MEMORANDUM

To: Salt Lake City Planning Commission
From: Michael McNamee, Principal Planner, michael.mcnamee@slcgov.com, 801-535-7226
Date: September 13, 2023
Re: Modifications to Design Review Approval for Chromeworks Apartments (PLNPCM2022-01165)

Design Review

PROPERTY ADDRESS: 1050 S Washington Street
PARCEL ID: 15-12-406-007-0000; 15-12-406-015-0000; 15-12-406-016-0000; 15-12-406-018-0000
MASTER PLAN: Central Community
ZONING DISTRICT: CG (General Commercial District)

Proposed Roof Plan

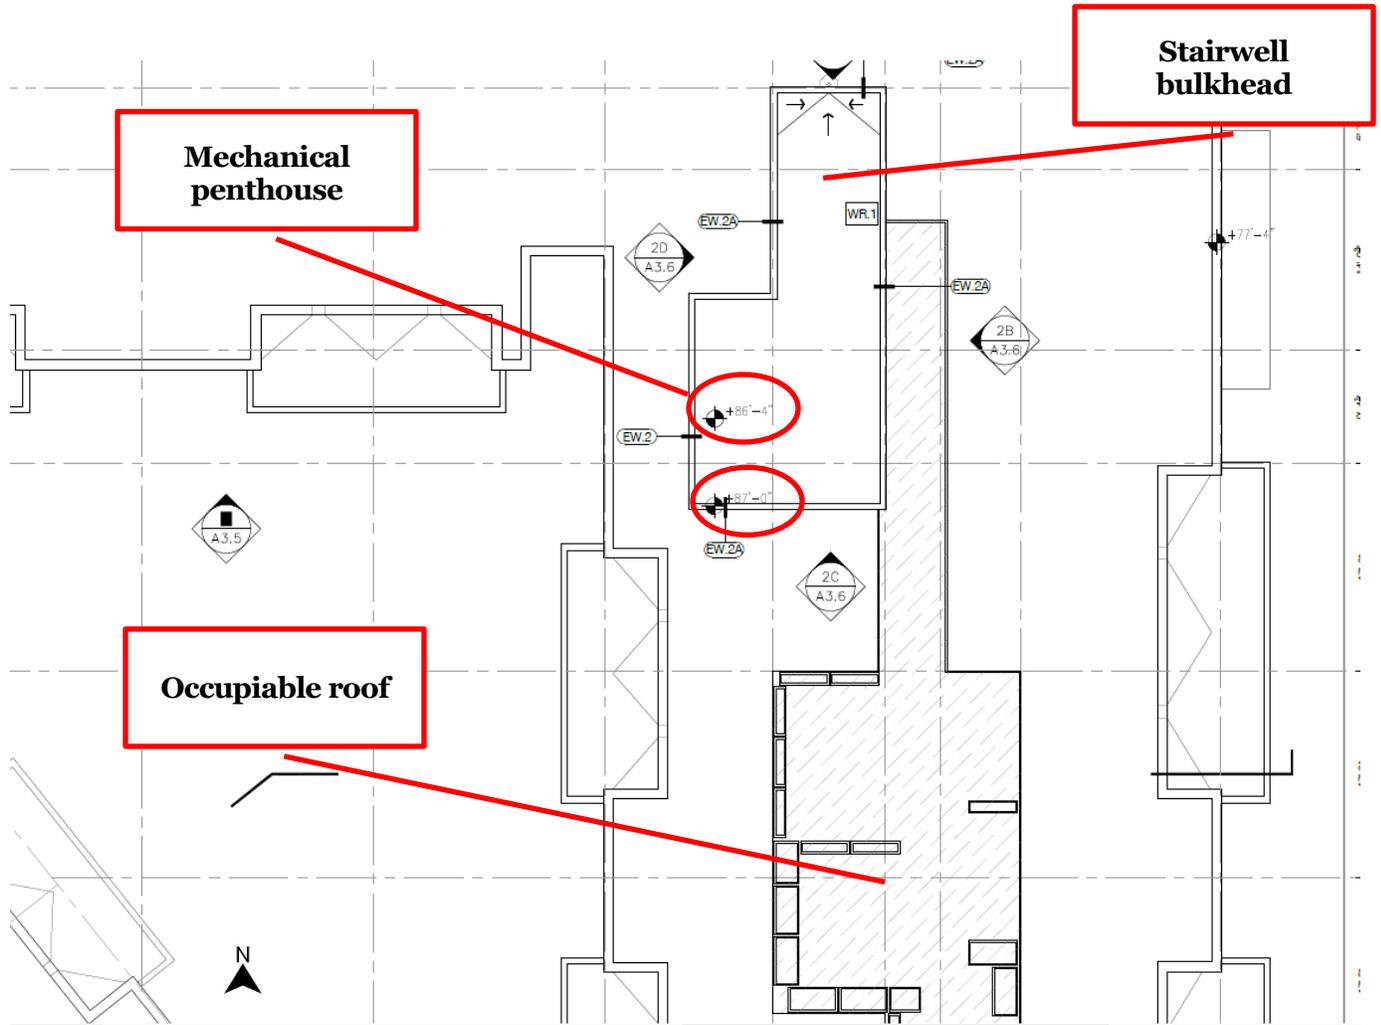
The proposed roof plan includes three mechanical penthouses which will each be 86'4" in height, with parapet walls that are 8" above that at 87' tall. A rooftop deck will sit on top of the roof. Walkways will lead from stairs and elevators to the mechanical rooms and rooftop deck. The stairs and elevators will not need approval through Design Review because they fit within the envelope that is allowed in the Height Exceptions table in the zoning ordinance. The elevator bulkhead will be the tallest structure on the roof, at 89'4", with parapet walls of 89'10". The Height Exceptions table allows for elevator and stairwell bulkheads that are up to 16 feet taller than the otherwise allowable height. From the previously approved height of 73'10", the elevator bulkheads will be 16' above.

Section A: Detail of northeast section of roof, with proposed heights circled

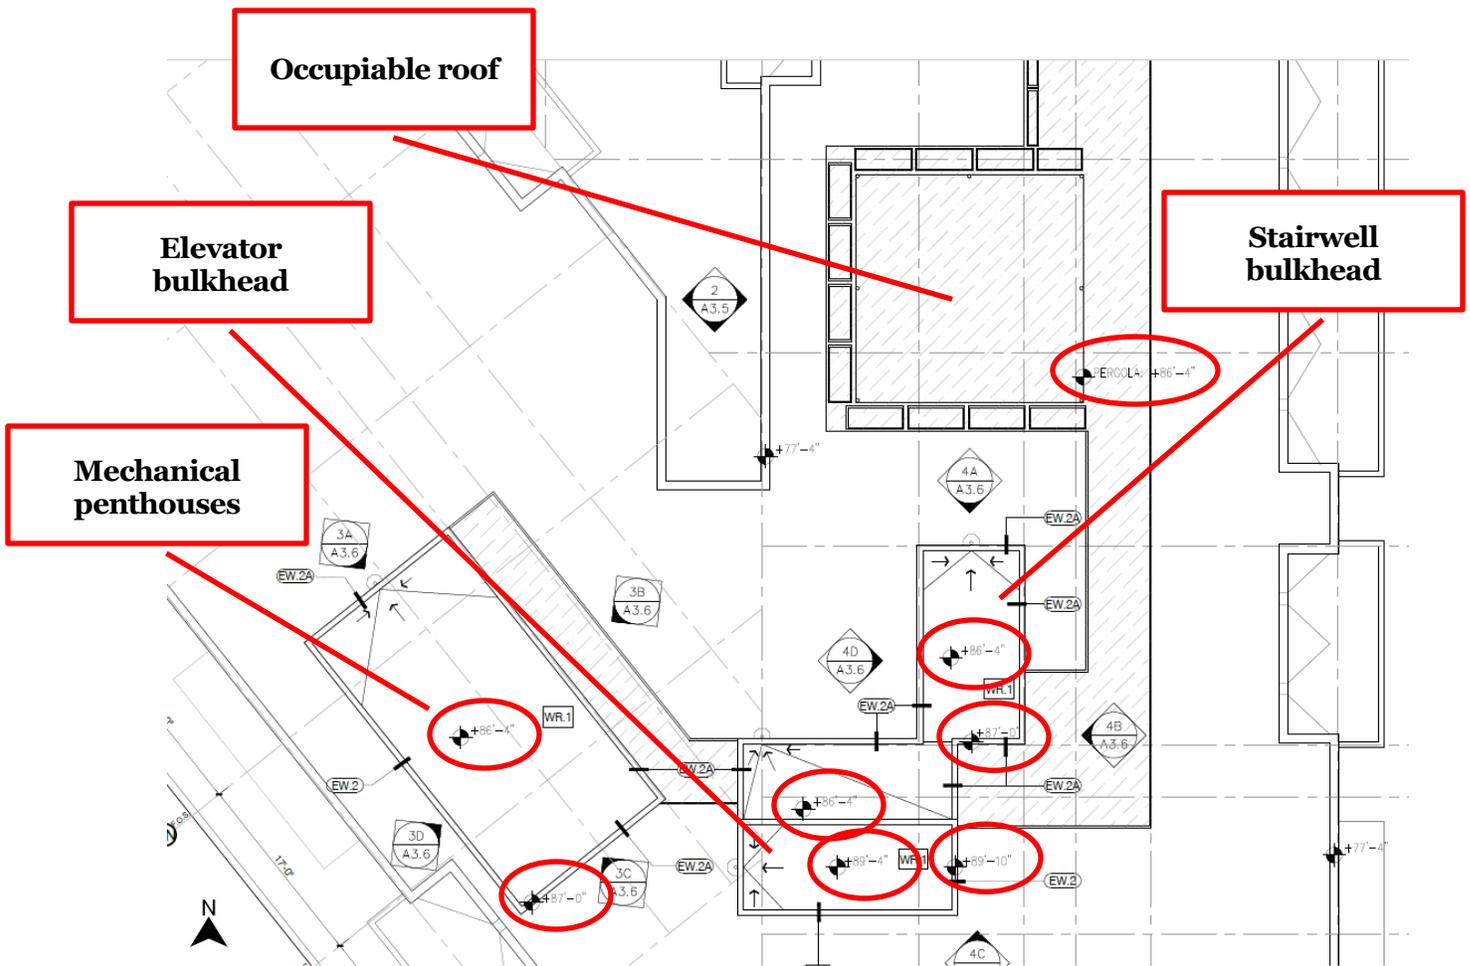
The northeast section of the roof will have a stairwell bulkhead and one mechanical penthouse, which will be 86'4", with parapet walls that extend to 87' in height. To the east of the stairwell and mechanical room, a walkway will extend to the south, connecting to occupiable roof space.

Proposed East Elevation (front)

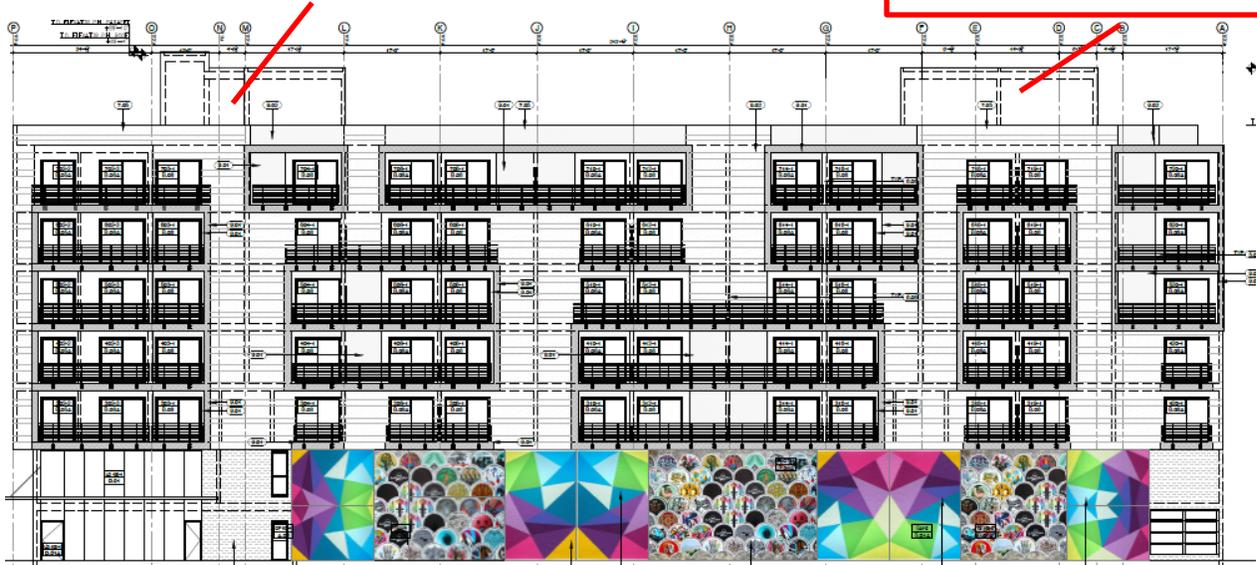
Elevator bulkhead, enclosed walkway, and stairwell bulkhead

Mechanical penthouses and stairwell bulkheads

Commentary: The revised front elevation reflects the rooftop elements that were previously not included in the elevation drawing. No other changes are proposed.

Proposed West Elevation (rear)

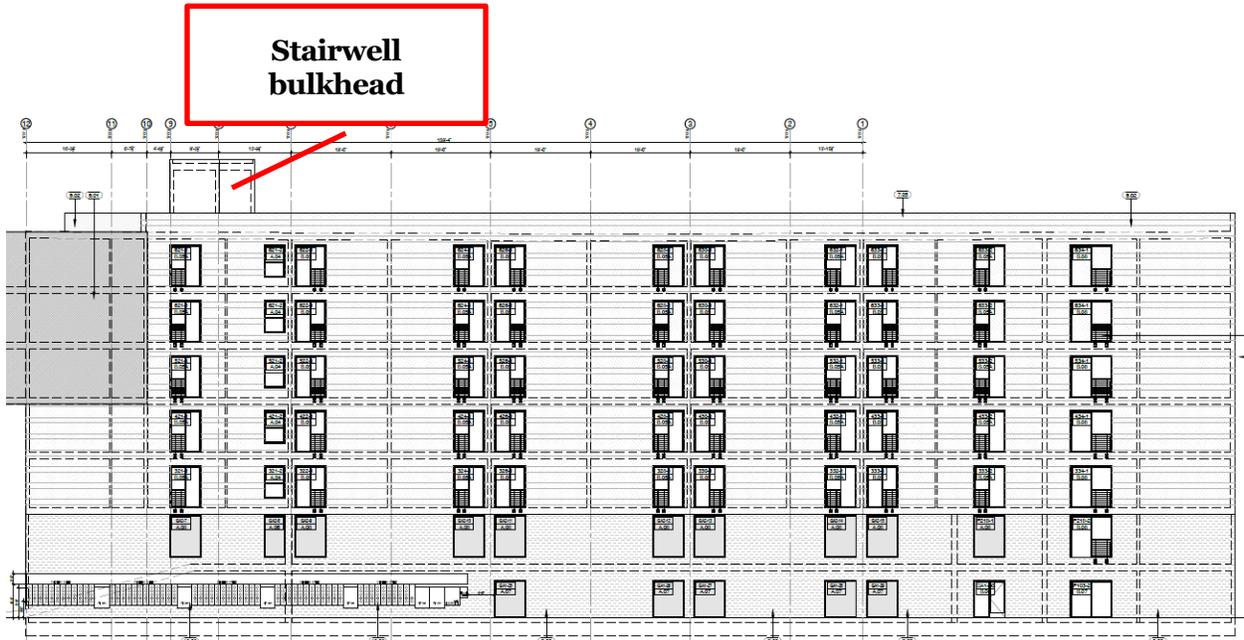
**Mechanical
penthouses**

Commentary: The revised rear elevation accurately reflects the height of the rooftop elements. No other changes are proposed.

Proposed North Elevation (side)

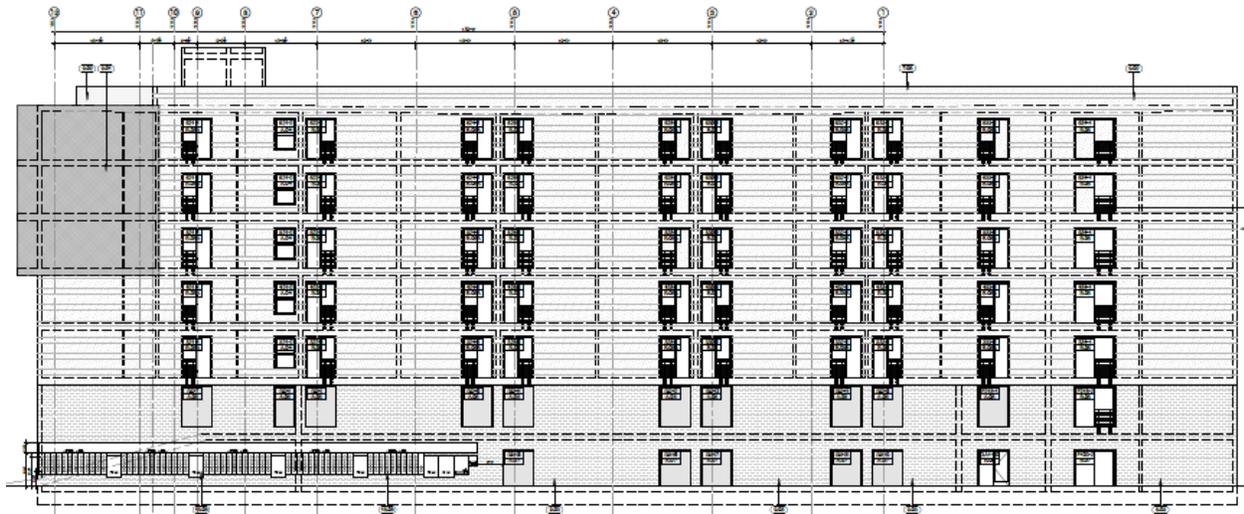
Commentary: The revised north side elevation accurately reflects the height of the rooftop elements. No other changes are proposed.

Proposed South Elevation (side)

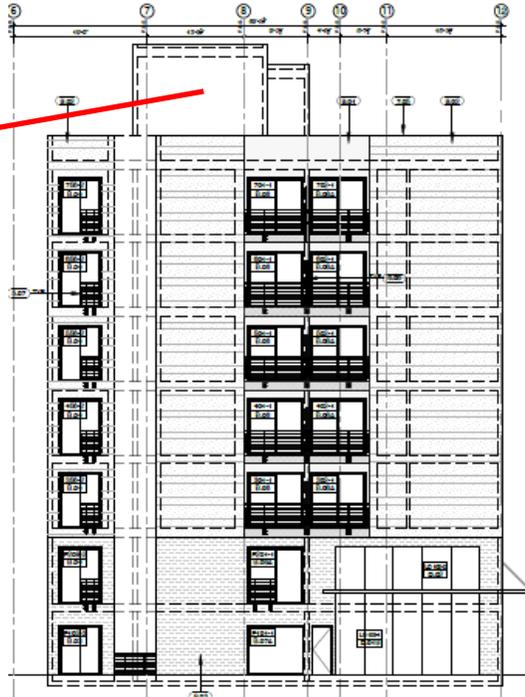
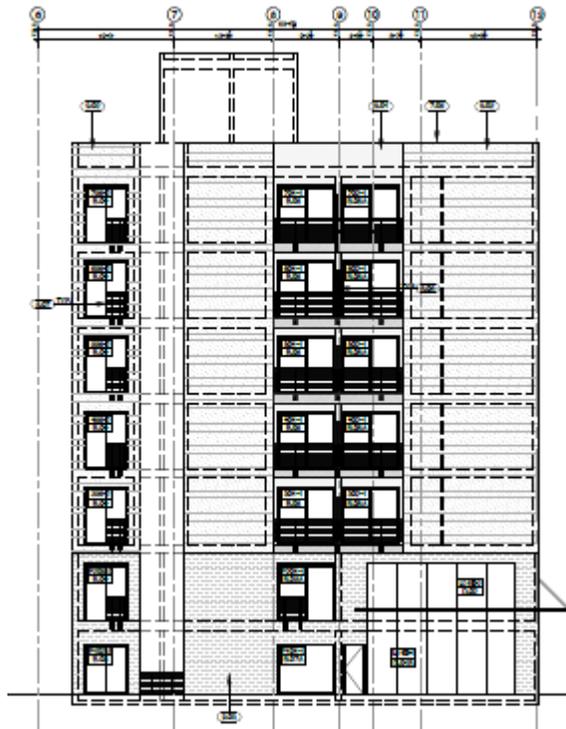
**Elevator and
stairwell
bulkheads**

Commentary: The revised south side elevation accurately reflects the height of the rooftop elements. No other changes are proposed.
